CONTRACT NO. 1819

**SCREEN REPLACEMENTS AT ELLA AND
CORLISS PUMP STATIONS**

ADDENDUM No. 2

1819_006A_MPLN_01
ELLA PUMP STATION
MECHANICAL BAR SCREEN PLANS

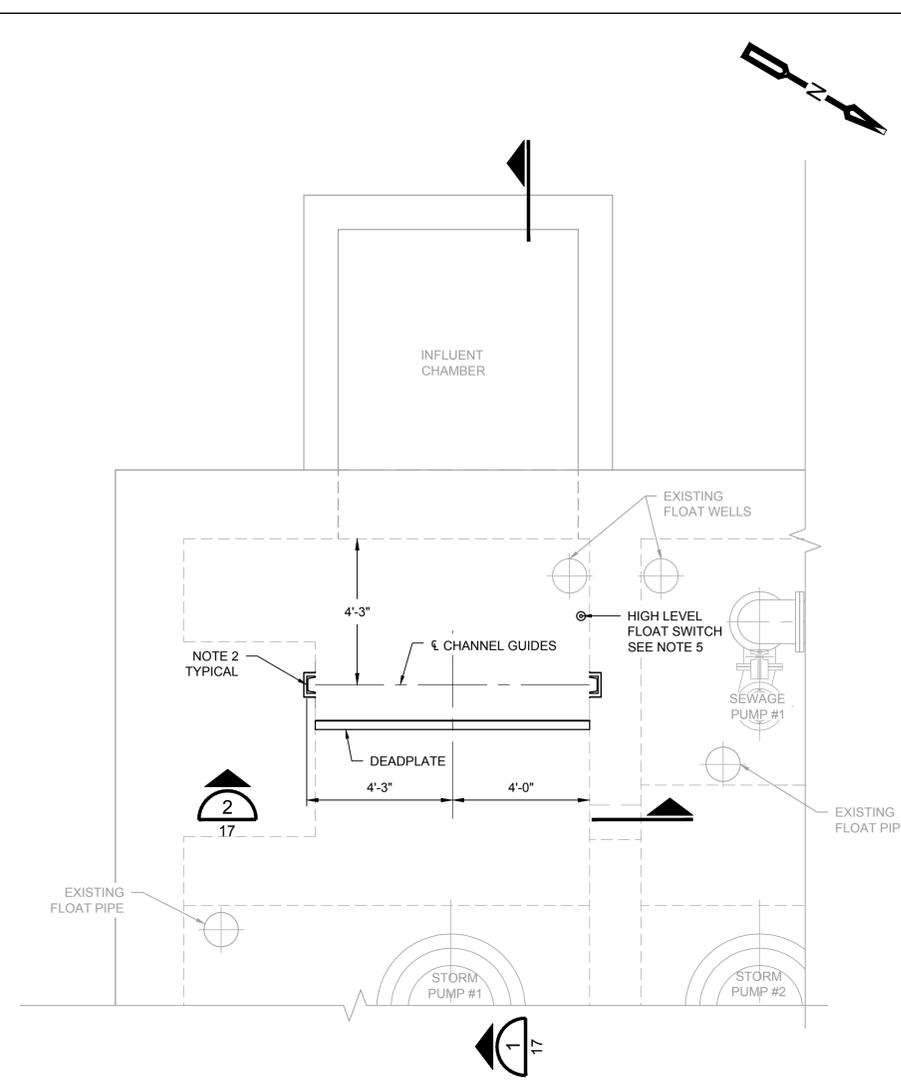
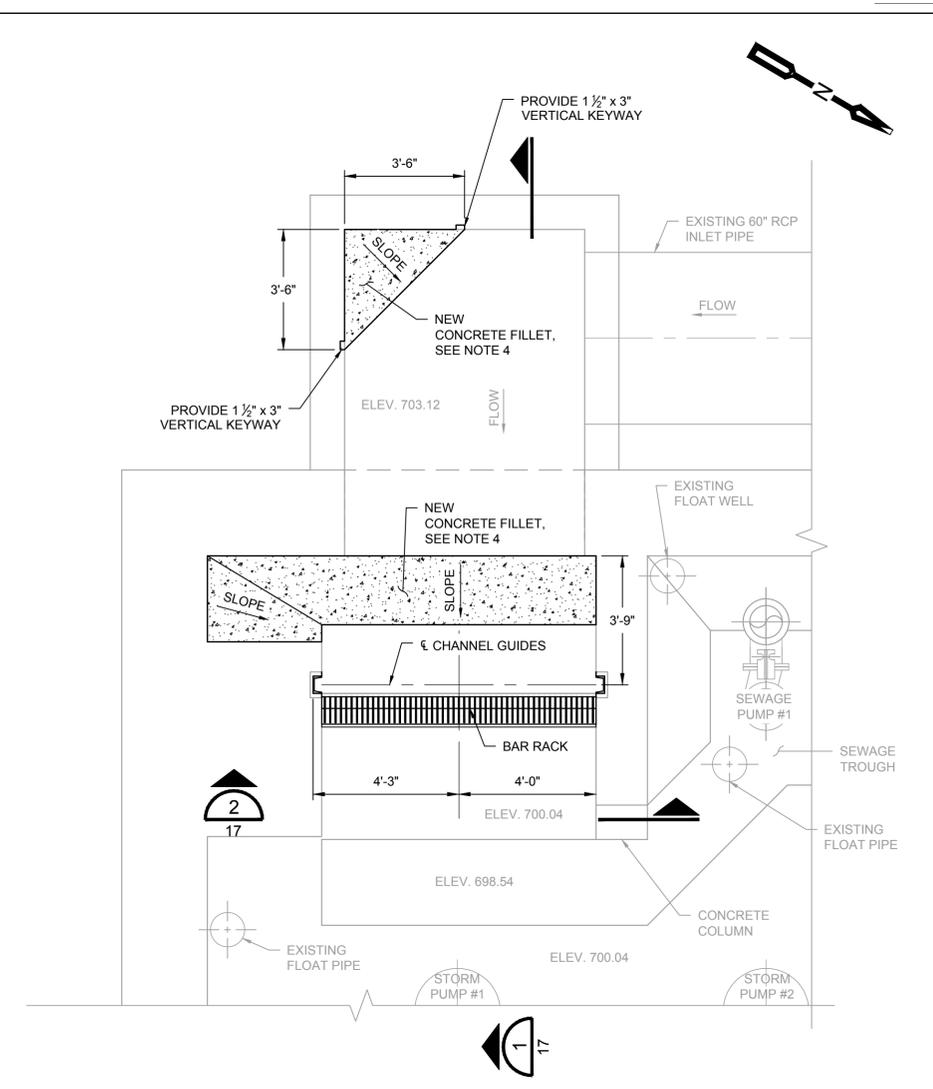
- ii. On sheet 16 of 34 there is roughly 14ft of handrail around the new bar screen. There are no specifications for this handrail. Please provide handrail specs.

Answer: A handrail specification, Section 05520 Handrails, has been ADDED to the Technical Specifications via Attachment A in Addendum 2. Plan A on Sheet 16 has also been REVISED via Attachment A in Addendum 2 to specify "New 42" high 3-rail 304 stainless steel handrail and toe plate around opening."

Corliss, O-13 Structure with prior work setup

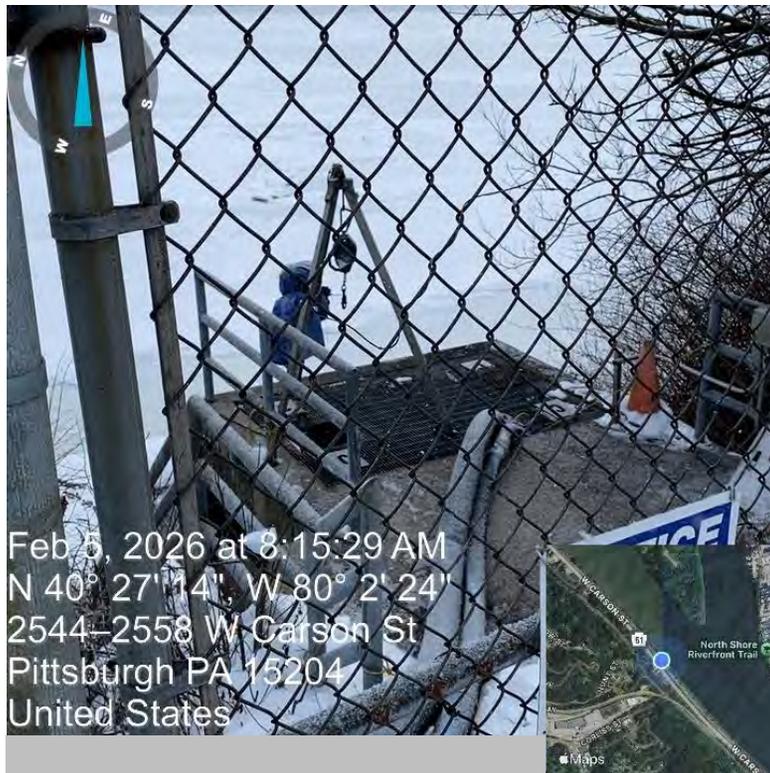
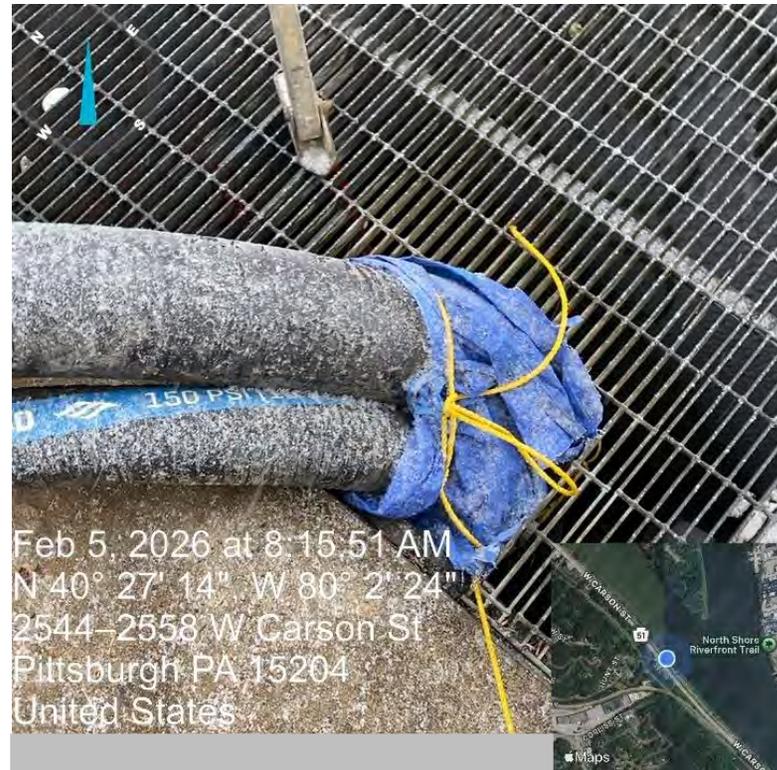
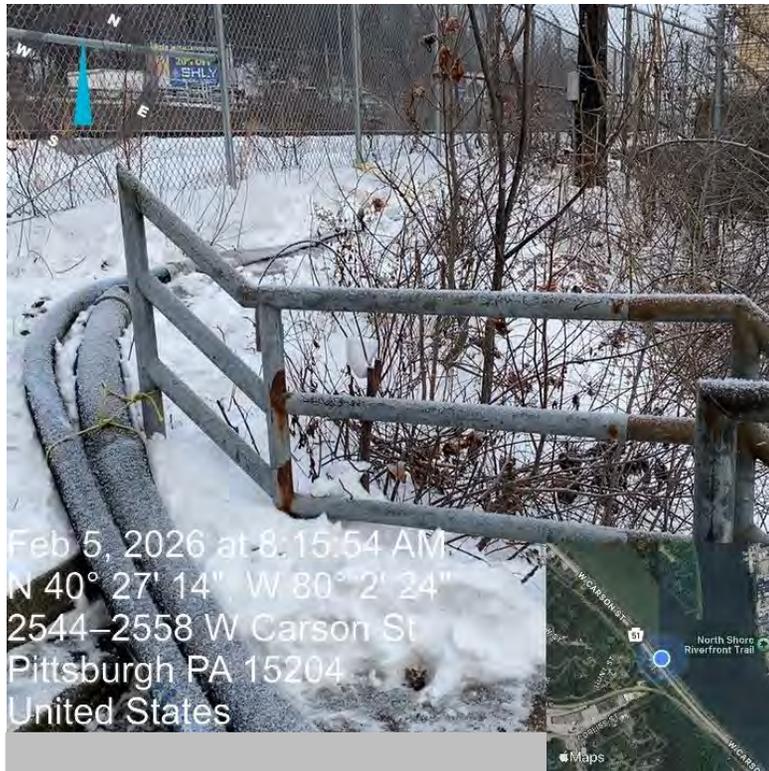
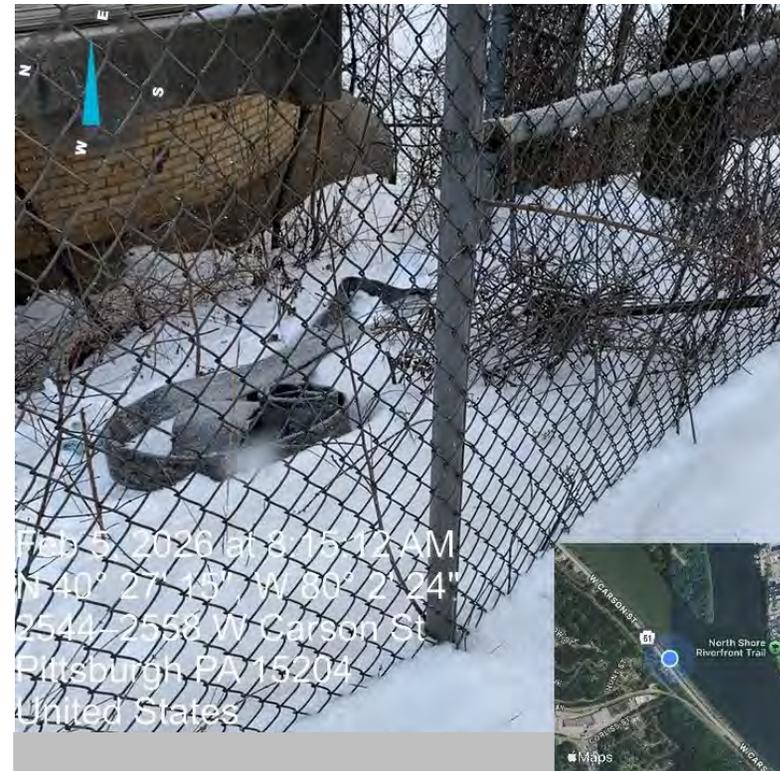
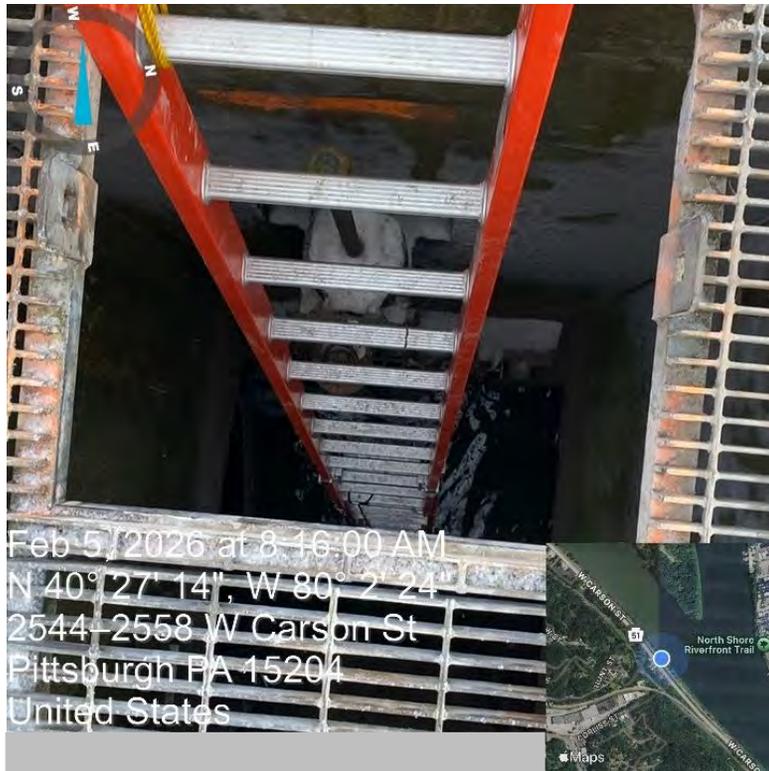
- iv. Corliss Pump Stations bypass location starting point O-13, no information has been provided about this structure in the bid documents, are there as-built documents available as to what where pumping out of and access into the structure, please advise.

- x. Please provide profile drawings and surrounding lines/structures for the 0-13-RG Combined Sewer Regulator.

Answer: Drawings and photos included in Addendum 1.

Answer: Drawings and photos included in Addendum 1 and this Addendum 2.
